Station Design Competition

East-West Bus Rapid Transit

Appendix A. Feedback Summary

2140

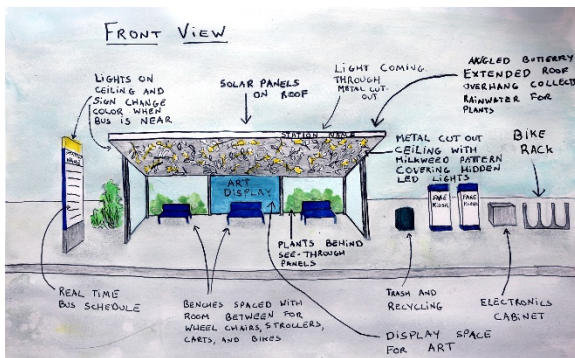
- Very busy – a lot going on.
- Will be hard to keep clean and maintained (broken/ clean glass, chairs, people sleeping, etc.)
- No bicycle features
- Seems very tall
- Obstruct views
- Green roofs are higher maintenance than other roof systems.

- Overall height, clerestory, green roof could challenge budget, but solvable.
- Cantilever roof excessive, but column(s) would not damage concept.
- Constructible if the columns are added to support the green roof ends.

4851

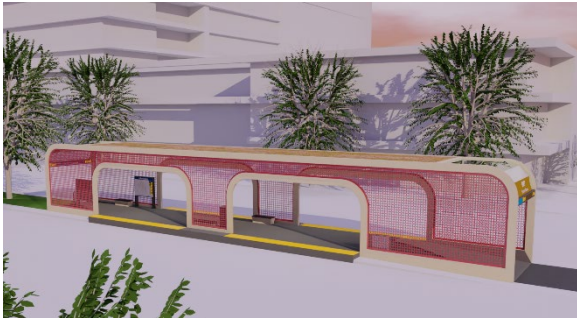
- The use of sandstone
- Plain, not many unique features
- Lacking amenities
- White/ light colors
- Does not appropriately leave room for all doors of the bus

- Need larger size of structural members, but plausible.
- May need gutters, downspouts and connection to storm drain

4915

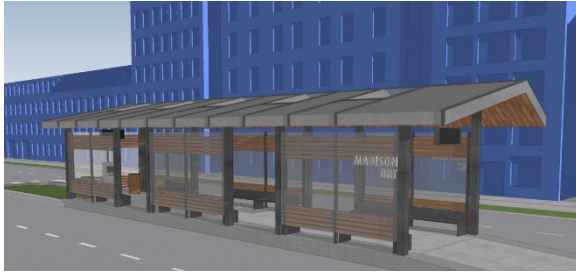
- Too retro, colors are flashy
- Doesn't look like Madison or midwest
- Design would not work well in cold weather.
- Not a great fit for historic context

- Needs additional vertical structure along length & interconnecting outside arch to inside arch
- Needs internal gutters & downspouts tied to storm drains
- Mesh material needs to be durable and sustainable

6143

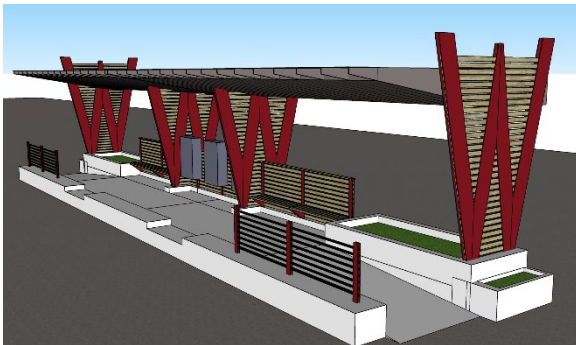
- Too open
- Trees are high maintenance/ impractical
- Circle seating – design and limits accessibility
- Wide/ massive
- Looks like a park or zoo shelter

- Structure not defined, but simple form allows easy introduction
- Not sure what tree elements are
- Probably needs more structural columns
- Needs gutters, downspouts & storm drain connection

7014

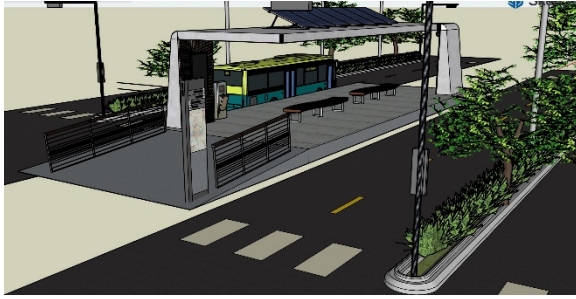
- Design is cliché
- Doesn't fit UW branding
- Not a great fit for historic context
- Not enough seating
- Little protection from weather
- Not scalable
- Wood finishes are more expensive to maintain

- Needs gutters, downspouts and storm drain connections.

8472

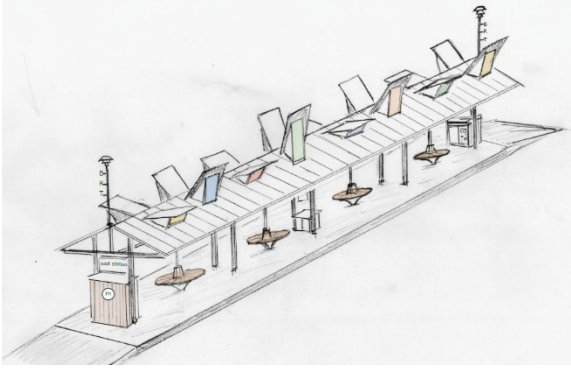
- Too unique
- Lacks any shelter
- Looks like a subway entrance, not BRT
- Dangerous - encourages people to climb up the roof
- Low ceiling clearance on one end
- Wood finish may have a higher maintenance cost than other finishes.

- Relationship of glulam to vertical support in 'w_Raingarden' picture confusing - meant to shed water from concave shape to sidewalk?
- Depending on highway transport regulations, could be prefab off-site and transported.
- Patron level screenings would need to be sustainable and durable.
- Need downspouts and connections to storm drain.
